PAGE CHANGE LIST

DESCRIPTION OF CHANGES

TECHNICAL SPECIFICATIONS

PROPOSED TECHNICAL SPECIFICATIONS

FIGURE 3.2-1

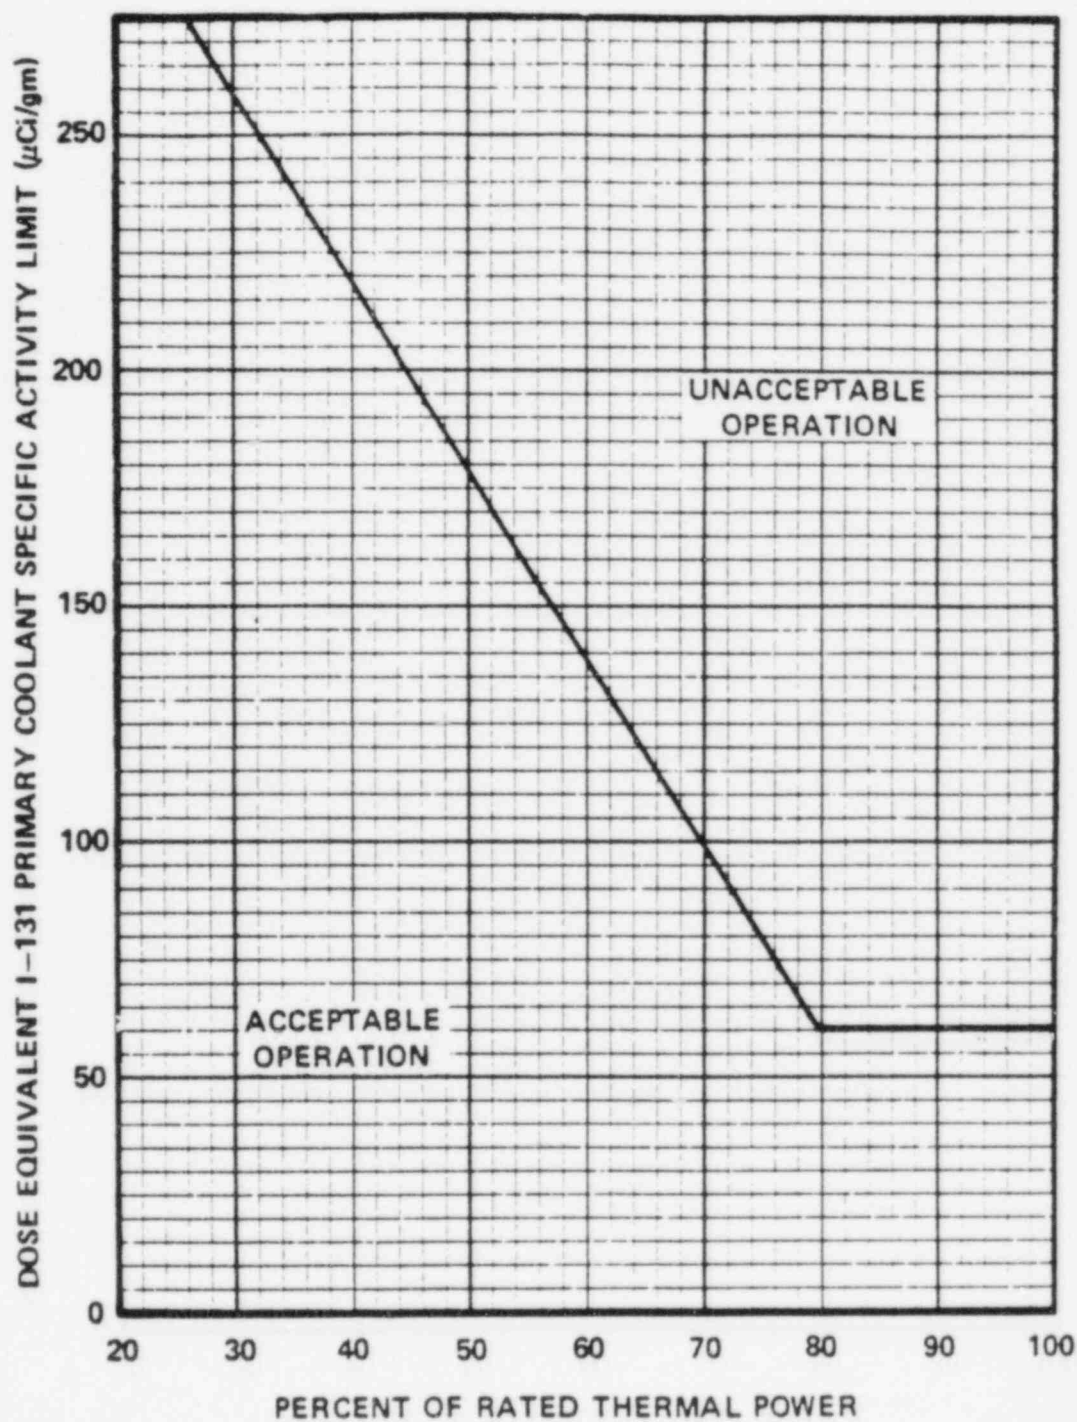
3.2-2	Figure 3.2-1
-------	--------------

PAGE 3.2-1

The Specification has been revised following the recommendations of Generic Letter 85-19 (Reporting Requirements on Primary Coolant Iodine Spikes). As described in the Generic Letter, the immediate reporting requirements of indications of significant degradation of fuel is already incorporated in the implementation of 10 CFR 50.73 (Licensee Event Reporting System). The reporting requirement stated in our Technical Specifications have been replaced with the recommended reporting requirements and moved to the Administrative Controls section of the Technical Specifications. In addition, we are incorporating the figure from Combustion Engineering Standard Technical Specifications concerning dose equivalent Iodine 131 concentration in primary coolant vs. rated thermal power. This Figure shows acceptable and unacceptable operating regions. The current Maine Yankee Technical Specification limit for iodine spikes less than 60 microcuries/gram will continue to be in effect at or above 80% rated thermal power. The limit on the figure increases below 80% rated thermal power and has been found acceptable by the Staff for other Combustion Engineering plants on a generic basis.

Remedial Action: If the specific activity of the primary coolant is greater than 1.0 microcurie/gram DOSE EQUIVALENT I-131 for more than 48 hours during one continuous time interval or exceeds the limit line shown on Figure 3.2-1, the reactor must be made subcritical with T_{avg} less than 500°F within 6 hours (Condition 4, Transthermal).
